# Economic and Social Council

#### Working Party on General Safety Provisions

#### 111th session

## Report of the Working Party on General Safety Provisions on its 111th session (11-14 October 2016)

"Figure 1

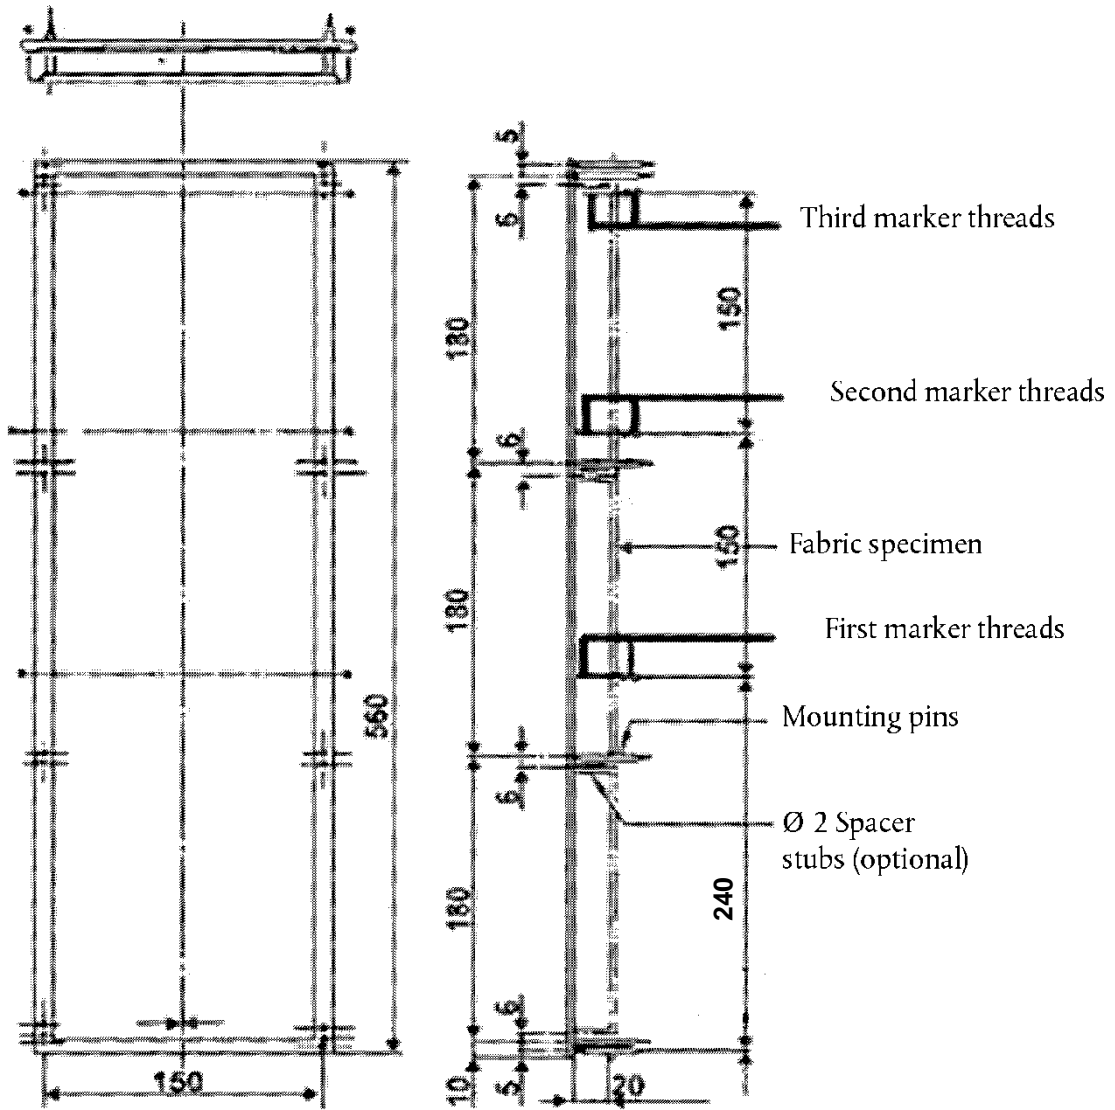
**The specimen holder shown in Figure 1 may be modified in width to allow the fixation of the sample.**

*Figure 1, amend to read (removing "Burner" at the bottom and replacing "220" by "240"):*

**Specimen holder** (Dimensions in millimetres)
